**APPLICATION FORM FOR
TYPE I MODIFICATION
TO SOLID WASTE MANAGEMENT
FACILITY PERMIT**

Type I-B Permit Modification Application
Supplemental Information
Merrimack Station Coal Ash Landfill
Bow, New Hampshire
Permit No. DPHS-SW-85-012

CLOSURE PLAN
Merrimack Station Coal Ash Landfill
Bow, New Hampshire

3
COVER SYSTEM TRANSITION DETAIL
N.T.S.

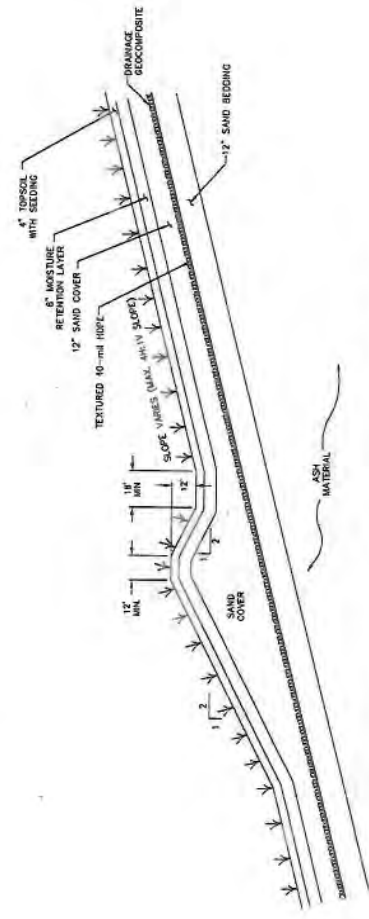
The current approved cover system consists of 12 inches of Sand Bedding overlain by 36-mil Hypalon geomembrane, which is in turn overlain by 18 inches of Sand Cover and 4 inches of topsoil. The cover system proposed to be used in the remainder of the landfill includes the following layers in vertically ascending order:

- 12 inches of Sand Bedding;
- 40-mil textured high density polyethylene (HDPE) geomembrane;
- Drainage geocomposite;
- 12 inches of Sand Cover;
- 6 inches of Moisture Retention Soil; and
- 4 inches of topsoil, which is fertilized and seeded.

- NOTES:**
1. CAREFULLY EXPOSE EDGE OF EXISTING HYPALON GEOMEMBRANE CAP.
 2. SNEED SURFACE IN AREA OF OVERLAP TO REMOVE ALL SOIL.
 3. INSTALL TEXTURED 40-mil HOPE GEOMEMBRANE OVERLAP A MINIMUM OF 2 FEET ON THE EXISTING HYPALON GEOMEMBRANE.
 4. INSTALL REMAINDER OF COVER SYSTEM SOILS.
